Coed Darcy

Proposed Phase Boundary
 (Monitor Phase 43)

Contract Name:	Coed D'Arcy	O	ITOR	RFI No:	
Contract Number:	GNP/NJR/13773-2			Date Raised:	31/08/2010
Subject:	Review of DiMe Controlled Waters Risk Assessment				
To:	Howel Morris			Atkins	
From:	Simon Gibbons			URS

The following comments are provided in response to Atkins report 'DiMe Area Controlled Waters Risk Assessment', dated 11th August 2010, ref 5041216-REM-RPT-000372.

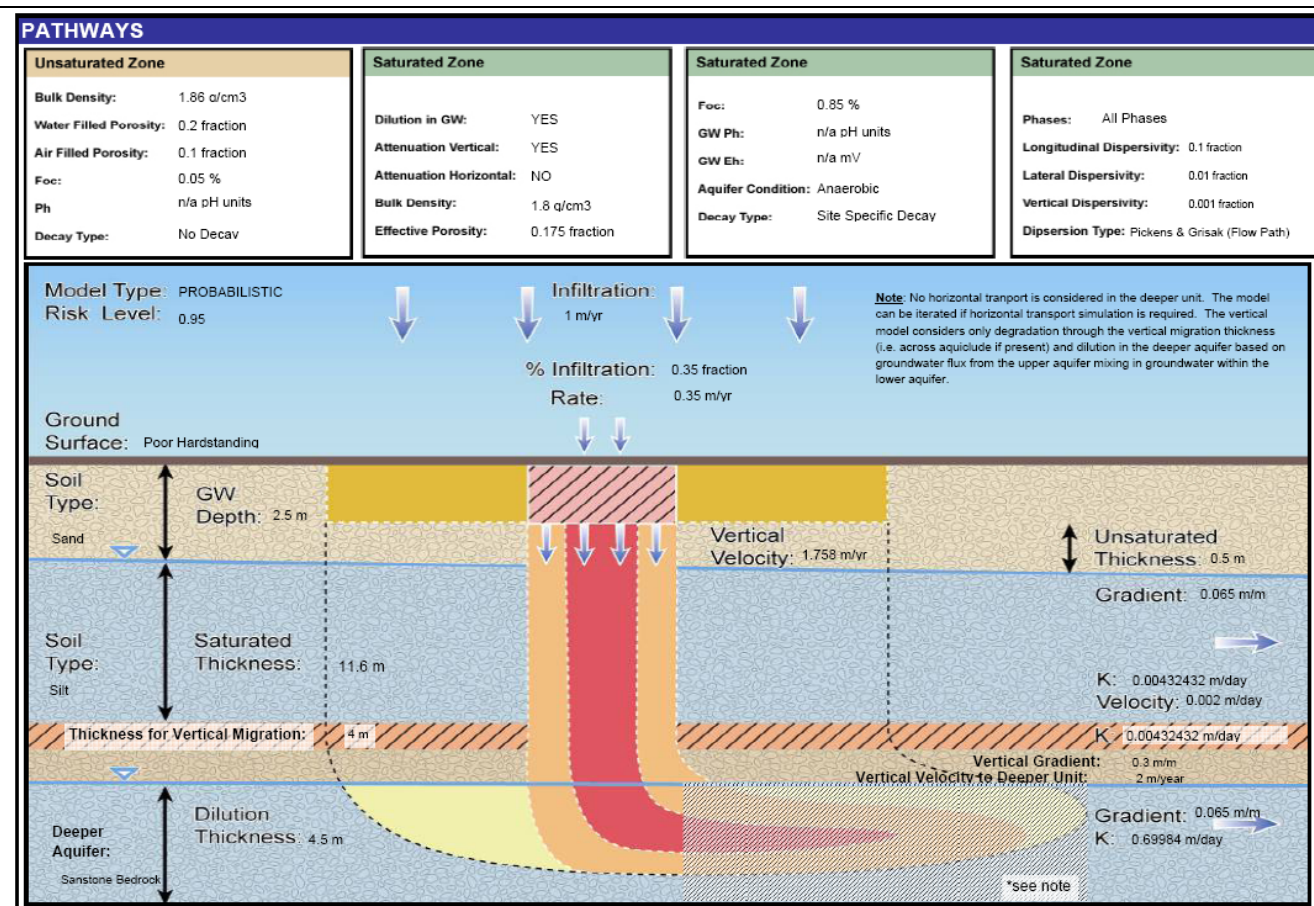
It is indicated that the predictive model is under predicting concentrations compared to the site data and the inference is that degradation is slower than the literature values used in the model. This is one of several reasons why the results might be different. It is indicated that the degradation rate has been increased in order to match the site data to the 50%ile simulated concentration. No data is provided on what this degradation rate is or what the calibration point is taken to be? Without this information the relevance of this model in the whole process can not be evaluated.

Based on URS review of potential degradation rates for the key contaminants, 2 years and 1.5 years for 1,2-DCA and DCM respectively is considered potentially more appropriate.

Can the titles in the tables in Section 5 be clarified? What is the target concentration – where does it apply and how does the model that has been set-up calculate the 40 year 50th percentile value.
